### **BOARD ACTION REPORT – APPEALABLE ITEM**

**Project Name:** 131 NW 1st Avenue  
**Project Location:** 131 NW 1st Avenue, Old School Square Historic District  
**Request:** Certificate of Appropriateness (2019-150)  
**Board:** Historic Preservation Board  
**Meeting Date:** November 6, 2019

## HISTORIC PRESERVATION BOARD STAFF REPORT

131 NW 1<sup>st</sup> Avenue

1 SITE PLAN  
3/16"=1'-0"

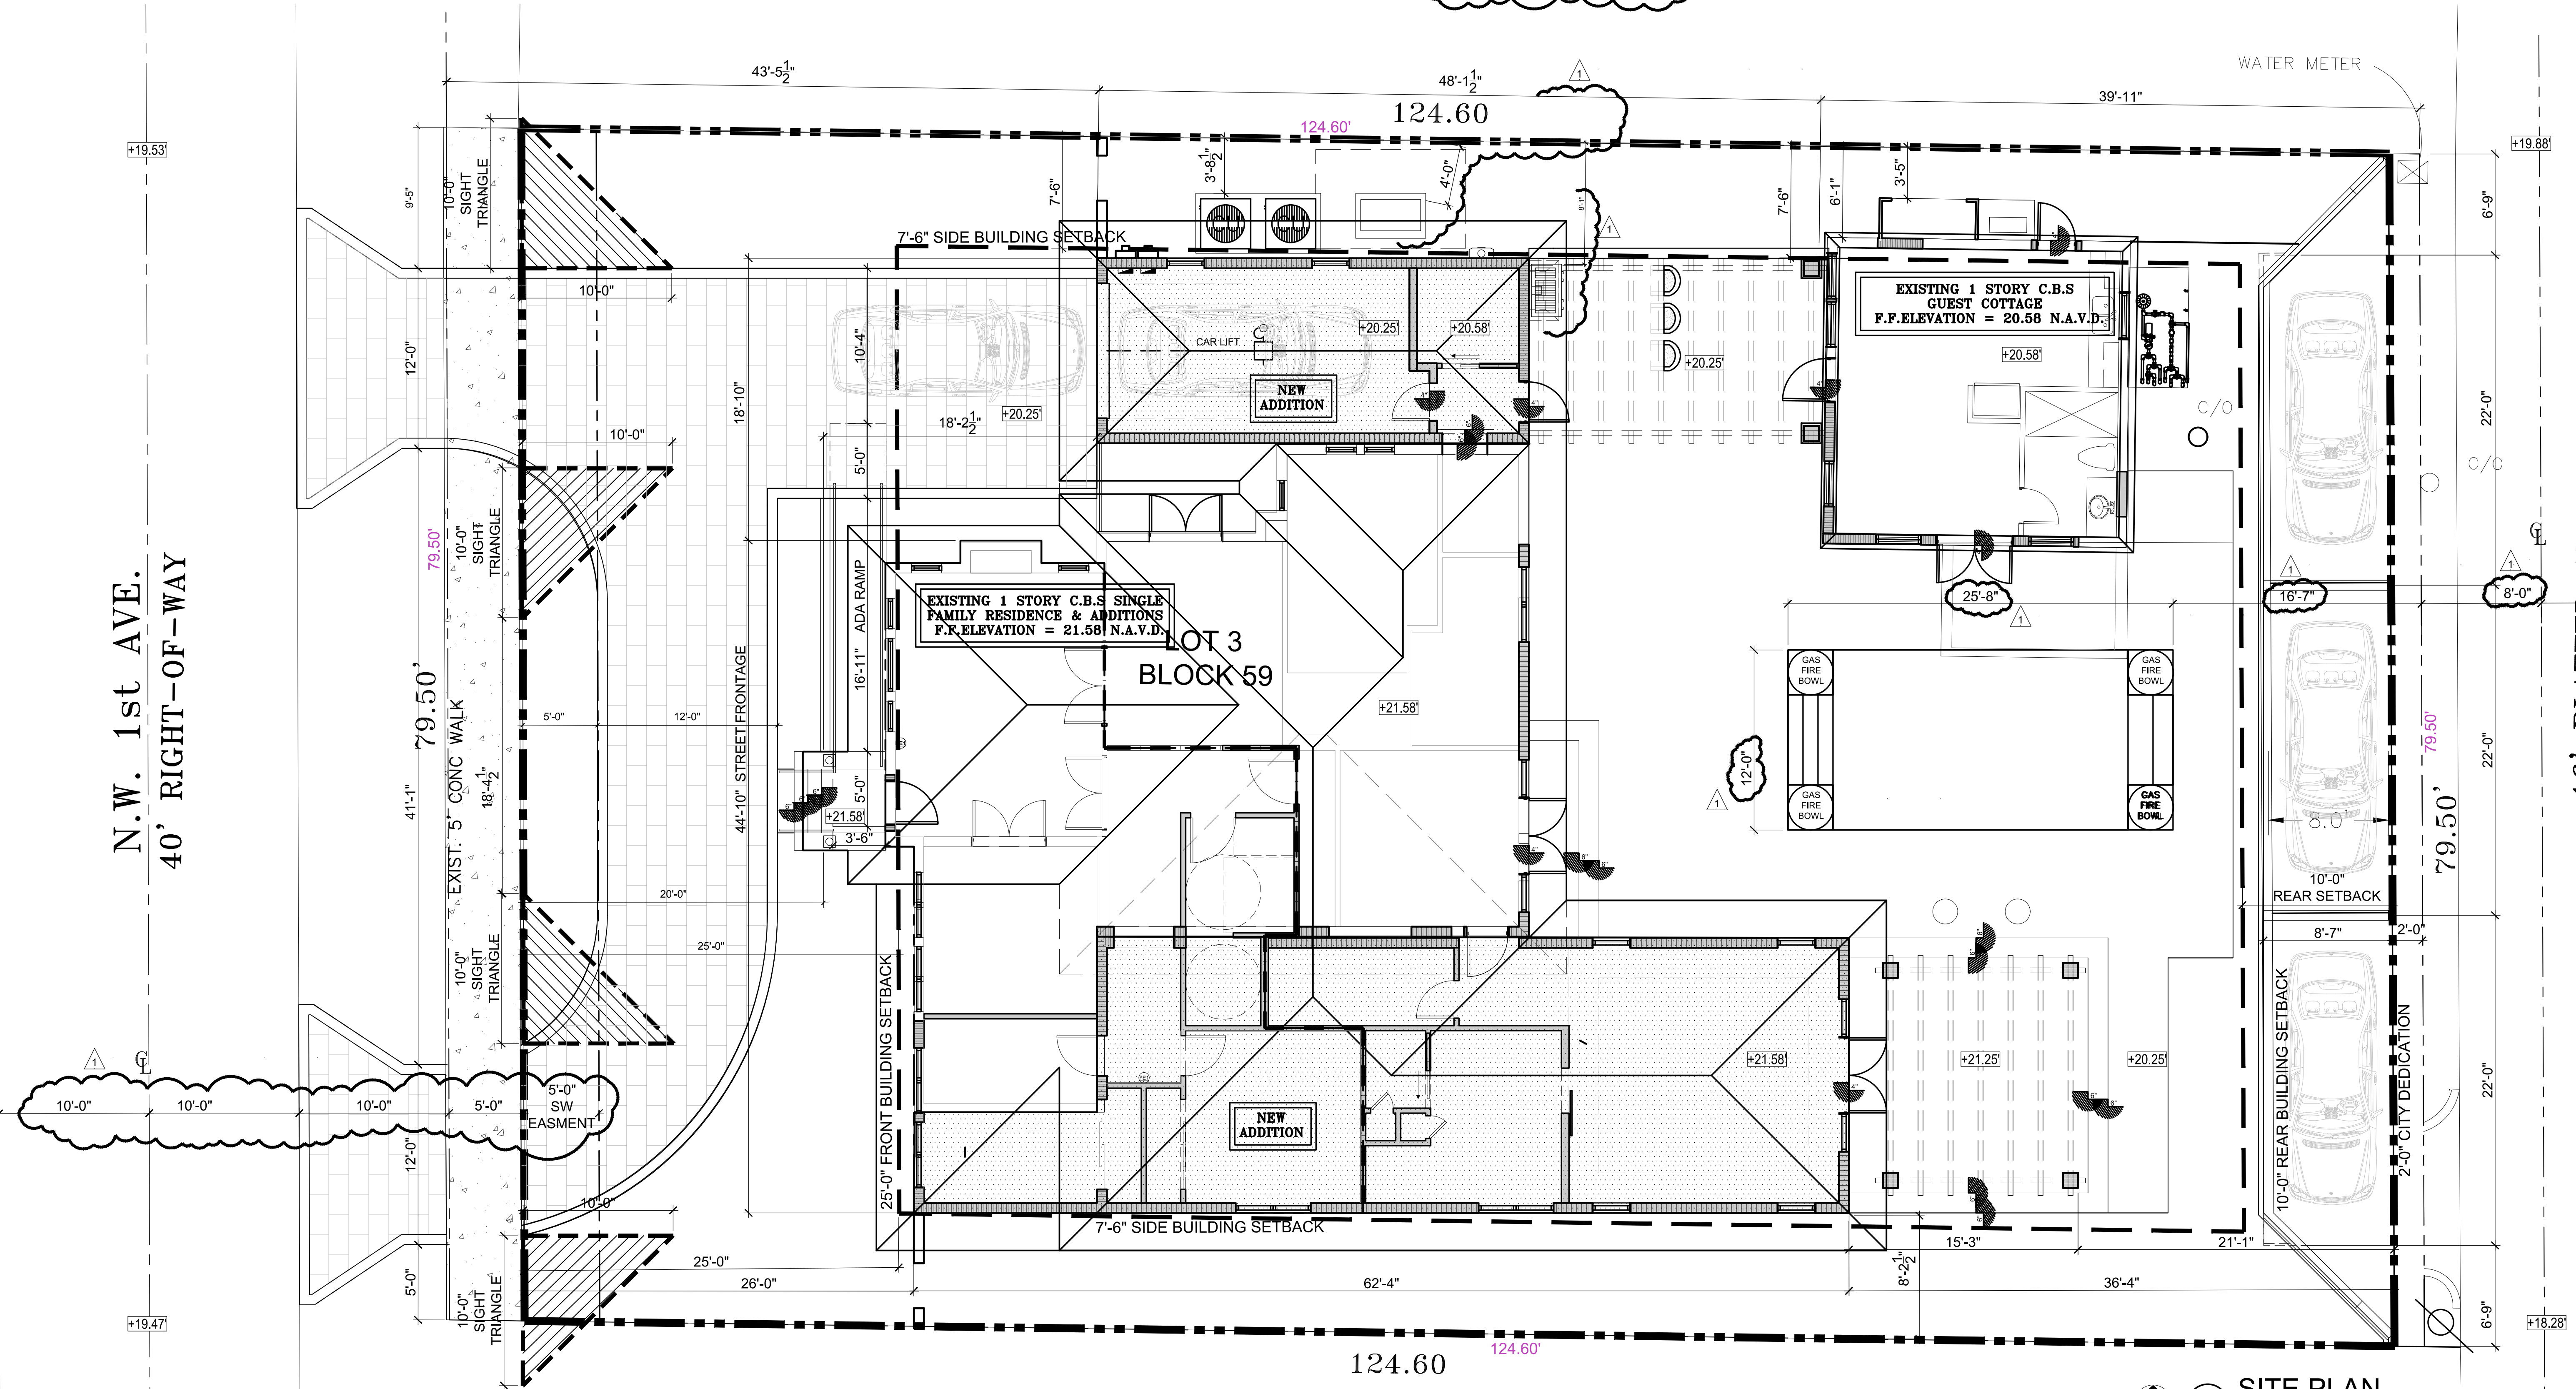
1. That the shared use parking calculation table be removed from the site plan;
2. That the rear setback for all structures be identified on the site plan;
3. That the percentage of existing and proposed open space and lot coverage be identified on the site plan;
4. That the existing square foot calculations for residential and office uses be identified on the site plan.
5. That the utility pole within the north/south alley on the east side of the property be moved closer to the property line to allow for the required amount of maneuver space for vehicles; and,
6. That site lighting calculations be provided on the Photometric Plan for the parking area on the east side of the property adjacent to the north/south alley.

1. That the shared use parking calculation table be removed from the site plan;
  2. That the rear setback for all structures be identified on the site plan;

3. That the percentage of existing and proposed open space and lot coverage be identified on the site plan;
  4. That the existing square foot calculations for residential and office uses be identified on the site plan.

- Business and professional offices shall provide one space per 300 square feet of total new or existing net floor area being converted to office use. This requirement may be reduced to one parking space per 400 sq. ft. of net floor area, or by at least one space, where there is a mix of residential and office use in the same structure. The parking calculations are as noted 1 space per 400 sq. ft. for the commercial floor area. The parking for the residential area is correct. Revise site data table relating to parking on sheets A101 & A101a to reflect such.

d. A vertical plank fence is more appropriate for Mediterranean Style architecture. Horizontal planking is more commonly used with more modern styles;

***ANSWER: Please refer to the revised parking calculations provided on sheet A100.***

**ANSWER: A vertical plank fence has been specified on the plans as requested. See Sheet A101**

A301e

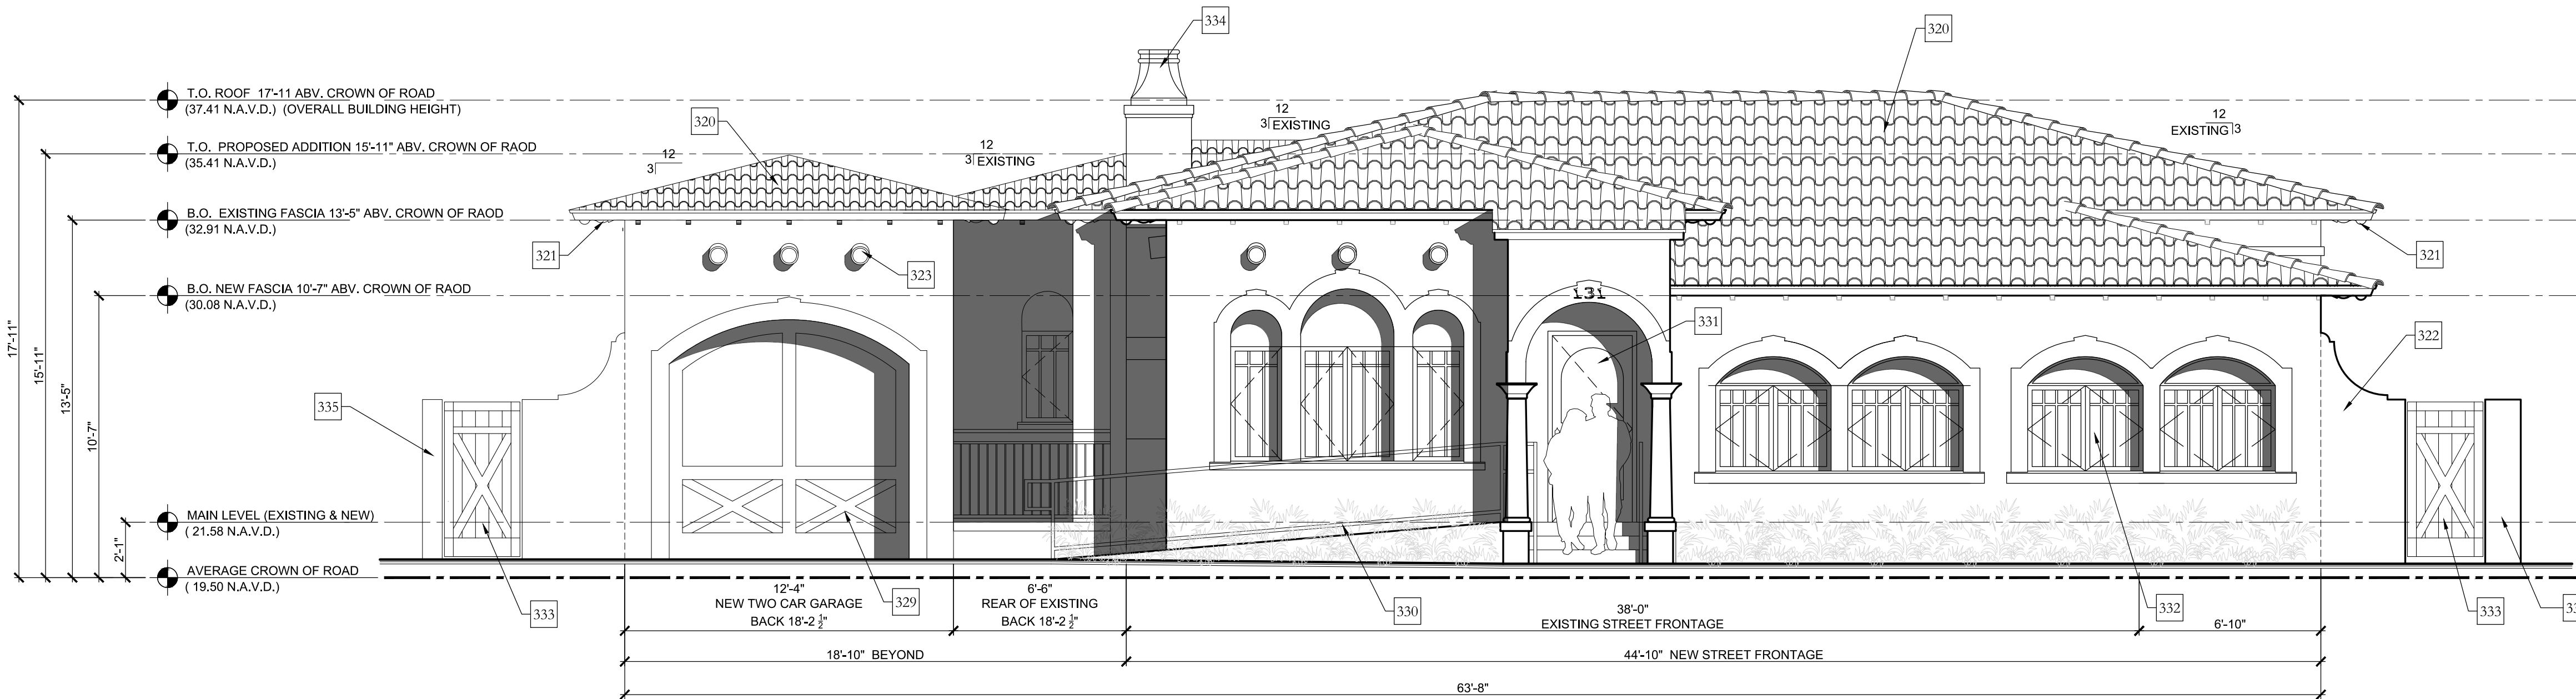
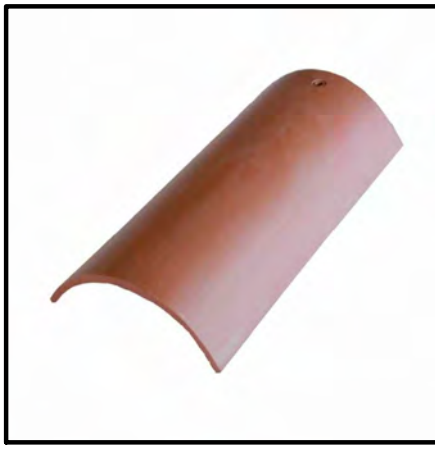
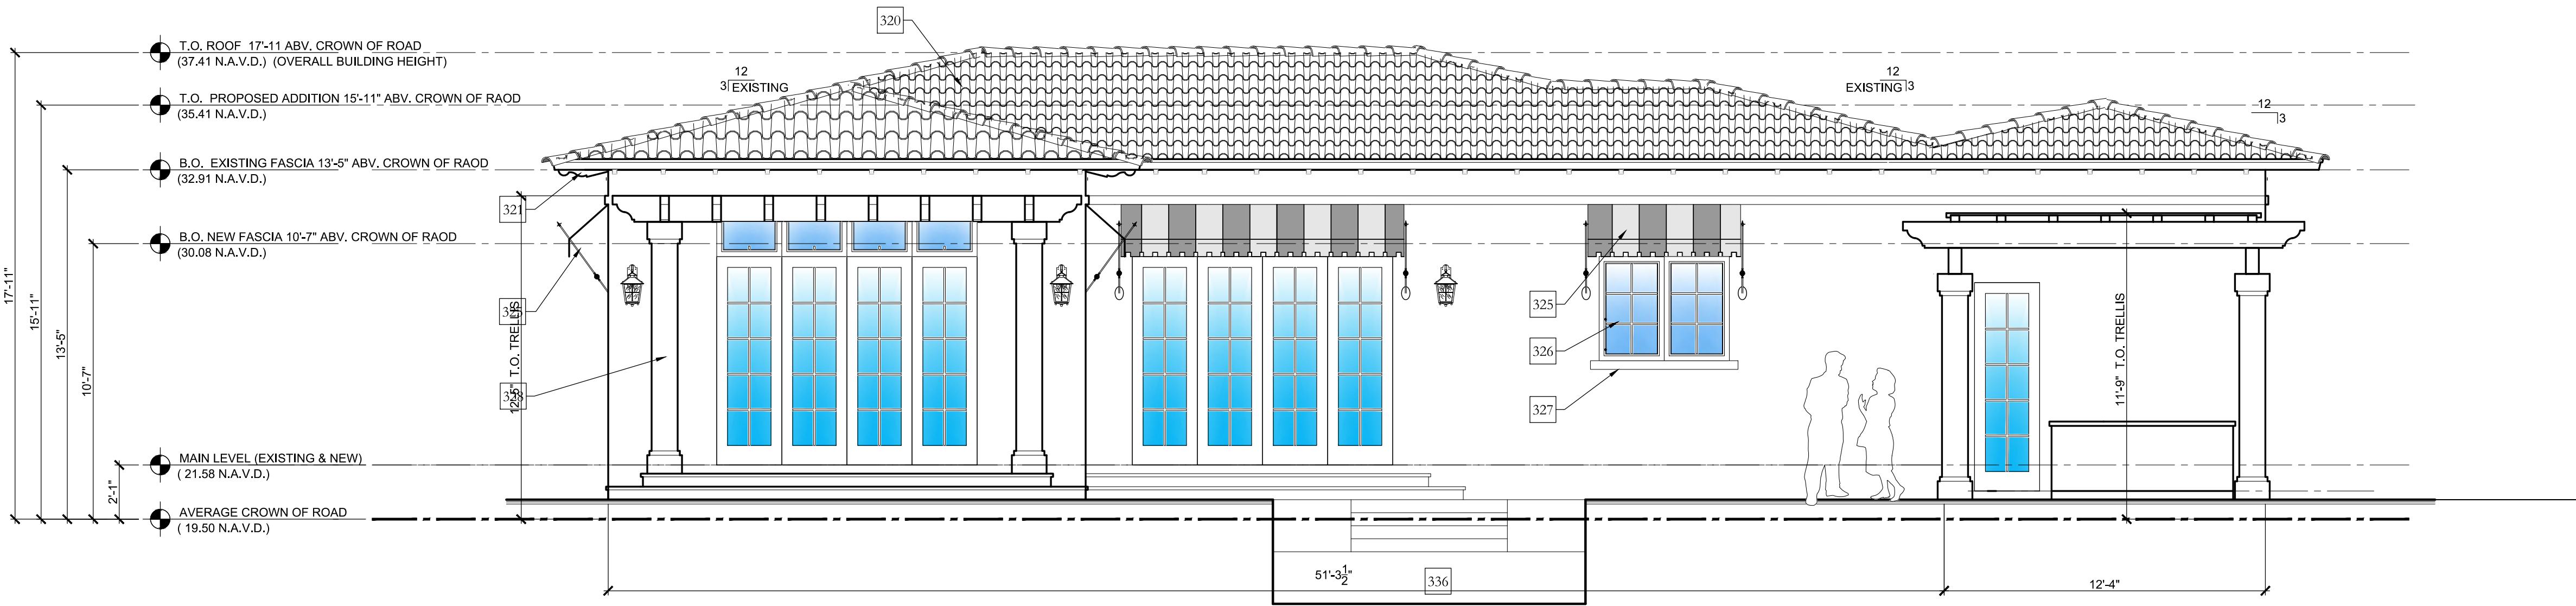
a. Maximum height measurement for historic first floor is 14 feet. There are currently two different measurements shown for bottom of fascia. Revise site plan sheets A301e – A302 to reflect accurate measurement;

**ANSWER: Please see revised elevations sheets A301e – A302 . The fascia heights were field verified and dimensioned based of the average crown of road.**

1 FRONT ELEVATION (WEST)  
1/4"=1'-0"

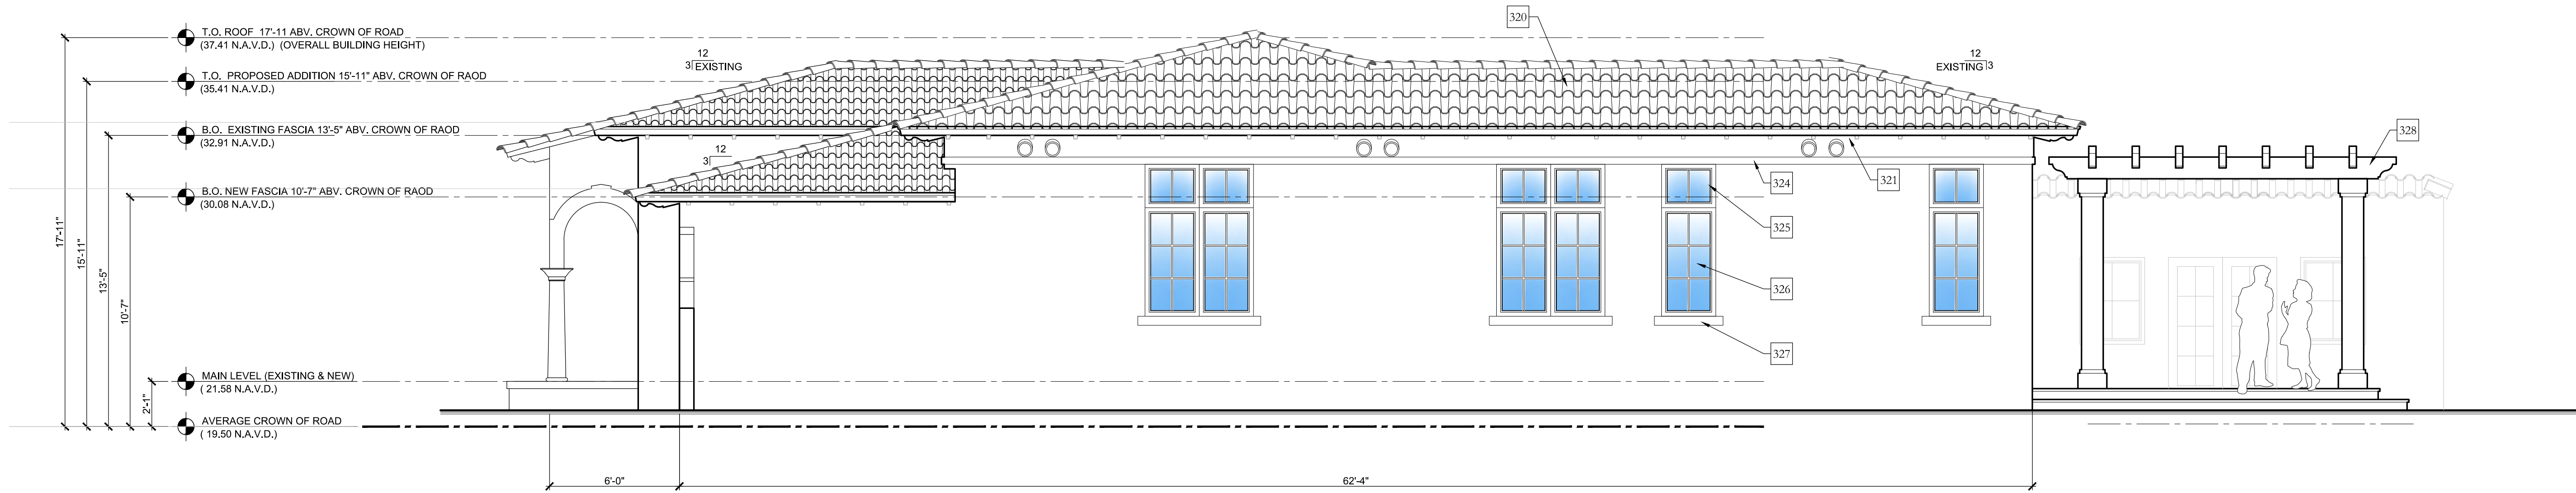
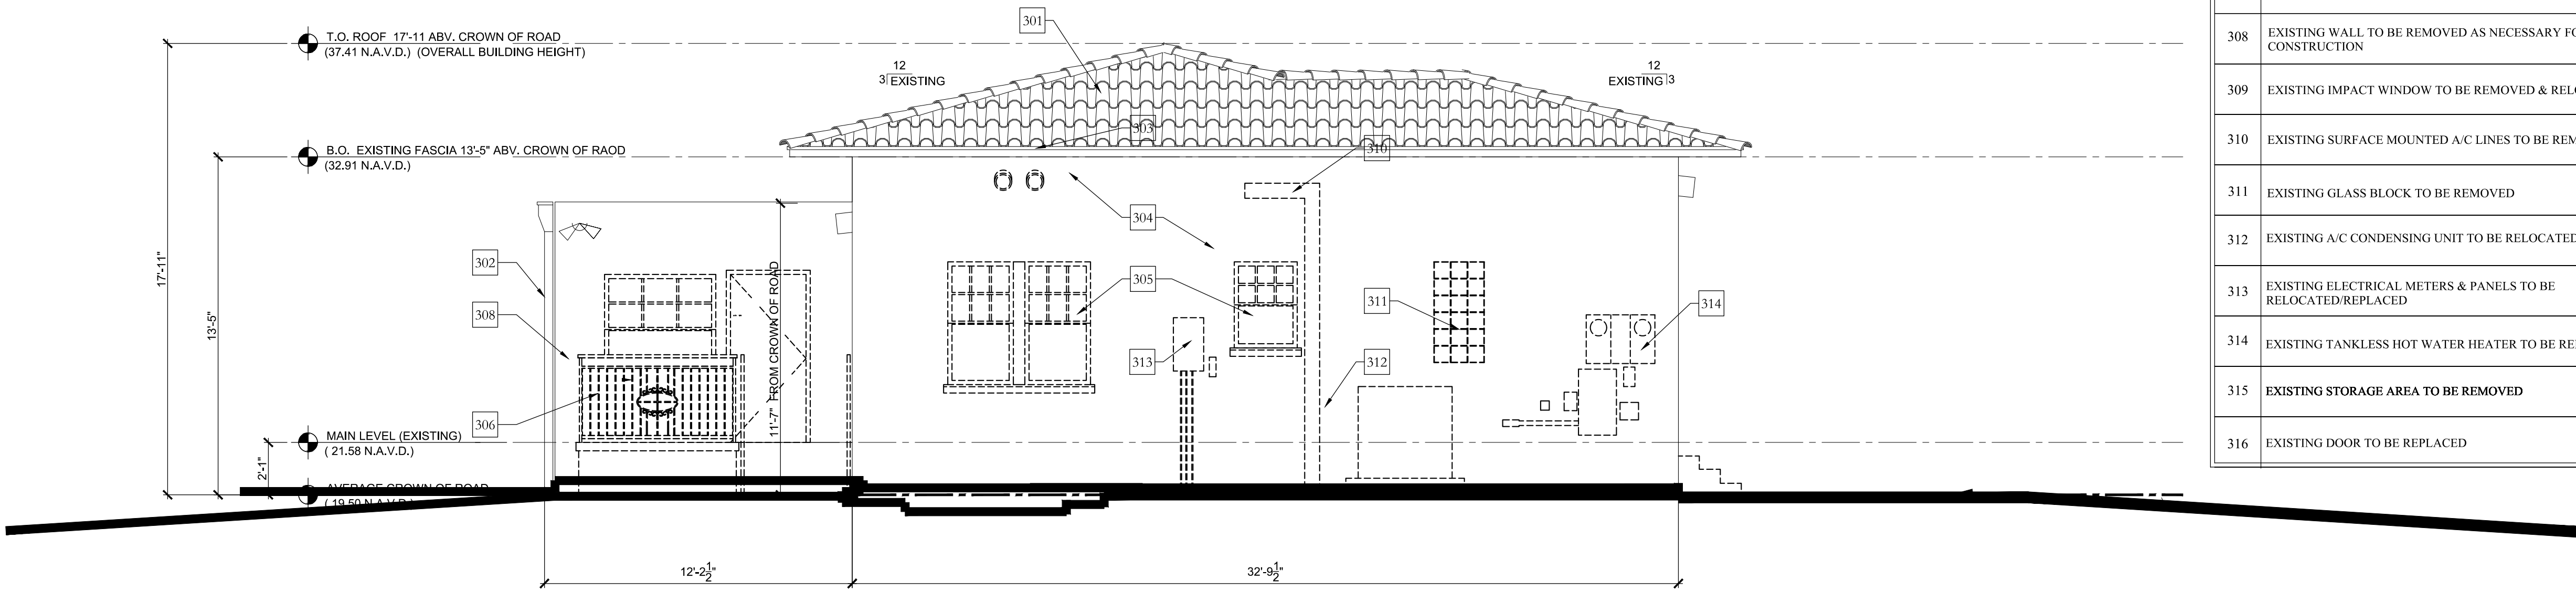
1. That the original three windows be retained and the 4<sup>th</sup> additional window be offset;
2. That the proposed additions include a type of textured stucco that is slightly different from the original; and,
3. That the proposed windows be clear glass with no reflectivity or tint.

The new addition to the south side of the structure includes a revised window pattern on the front façade (west side) by separating the 3 original windows and by introducing a 4<sup>th</sup> window. There is concern with the modification of the window pattern on the front façade as this change represents an alteration that changes the defining characteristics of the building and creates a false sense of historical context affecting the historical integrity of the structure, site, and environment. A condition of approval is added to retain the original window pattern of the front façade.

With respect to the Proportion of Openings (Windows and Doors) the addition to the south side of the structure proposes modification of the existing window pattern on the front façade by splitting the existing 3 window opening and adding a 4<sup>th</sup> window. This change negatively affects the original Proportion of Openings by introducing a conjectural feature not original to the historic structure. The replication of the original architectural design through the revised window pattern makes it difficult to decipher the originality of the window pattern by the trained eye. The front façade of a contributing structure is a vital part of the look and feel to the continuity of a historic district; therefore, it is crucial to maintain its authenticity. A condition of approval is added to retain the existing window pattern on the front façade of the main structure.
